E4417A-10

S E R V I C E N O T E

Agilent E4417A EPM-P Peak & Average Power Meter

Front Panel Dimension Might Not Be Suitable For Rack Mounting Solutions

Figure 1

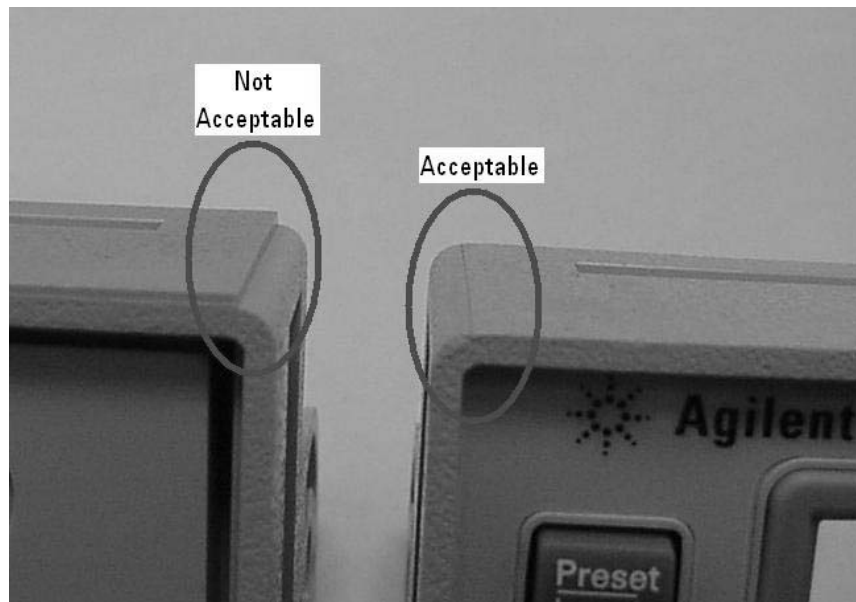
A tooling issue has resulted in some E4417A power meters being shipped with excess material on the top edge of the Front Panel Assembly. The height of this excess material varies, but it has been noted that when it exceeds 0.5mm the meter may no longer be suitable for rack mounting solutions.

Figure 1 shows the physical difference between an acceptable and an unacceptable Front Panel Assembly.

If the height of the excess material is 0.5mm (or less), then no further action is necessary.

If the height of the material exceeds 0.5mm, then the Front Panel Sub-assembly must be replaced (refer to Service Note E4417A-08 for instructions on how to remove & replace the Front Panel Sub-Assembly).
